**Caesar Rodney Institute  
Center for Energy & Environment**

**Public Comments Docket BOEM-2020-0005**

**Vineyard Wind 1 Offshore Wind Energy Project Supplement to the  
Draft Environmental Impact Statement**

**June 30, 2020**

Figure 3 from Parsons/Firestone offshore turbines make trip better or worse

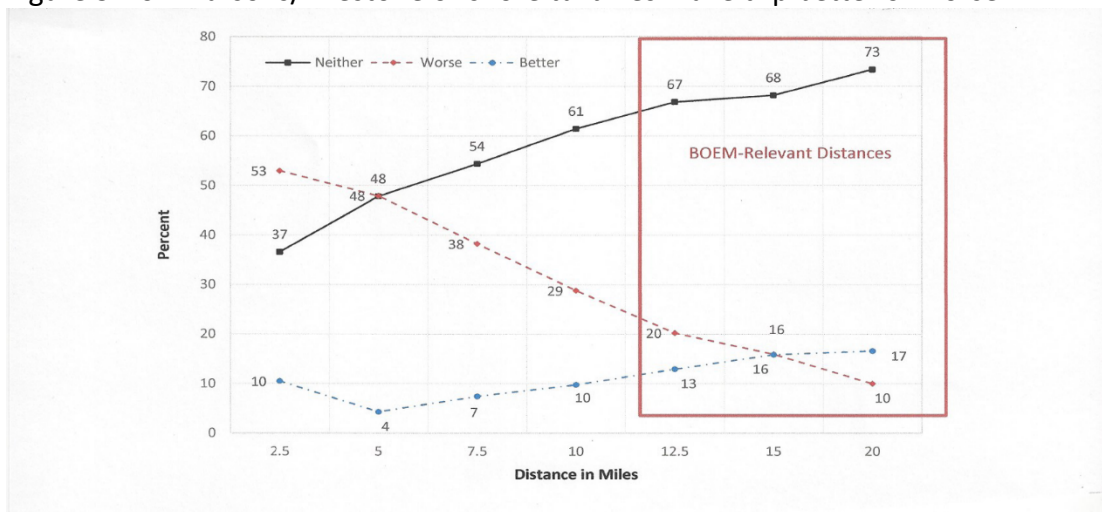
The summary of the study findings, and the study itself have several flaws. The Parsons/Firestone study used visualizations of a 579' tall turbine compared to the Vineyard current plan of using 837' tall turbines, and the turbines will be as close as 14 miles from shore. The taller turbines have the equivalent visual impact of moving the turbines 5 miles closer to shore in the Parsons/Firestone study, or equivalent to 10 miles. At 10 miles, survey respondents stated their recreational beach experience would be worse with turbines visible by a three to one margin (29 percent to 10 percent at 10 miles shown in Figure 3 below). Trip loss is expected to be 14 percent compared to trip gain from curiosity trips of 2.6 percent (see study Figure 5 below).

Figure 5 from Parsons/Firestone permanent trip loss V. curiosity trip gain

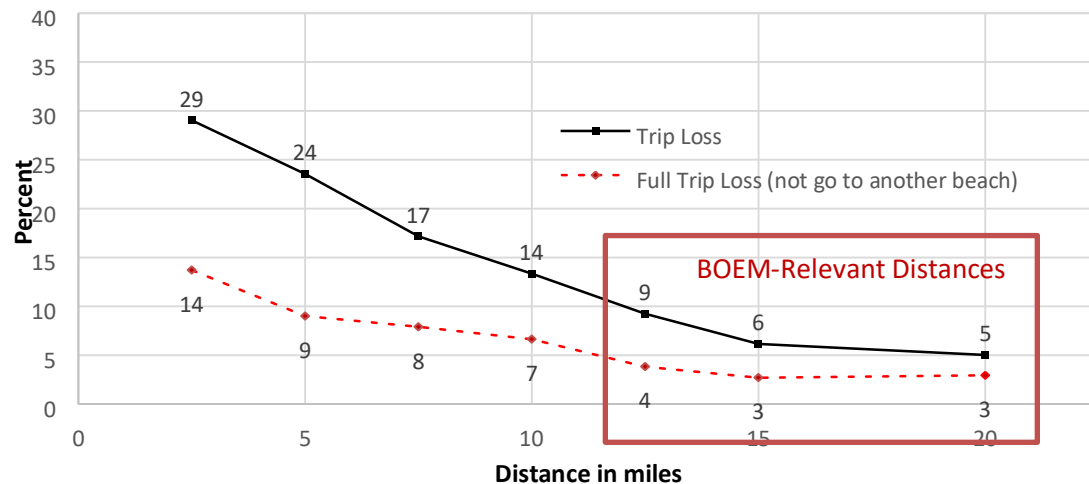
Further complicating the results, curiosity trips are a one-time event, while trip loss tends to be permanent. Also, negative responses about visible turbines were followed up, and adjusted for a measure of certainty while positive responses had no such follow up, or correction. The Parsons/Firestone study sample included people involved in beach activities (65 percent), and people who simply visited the beach area, but not the beach itself (35 percent) who would not be expected to oppose visible wind turbines. The Parsons/Firestone report stated property values would fall, but did not quantify by how much.
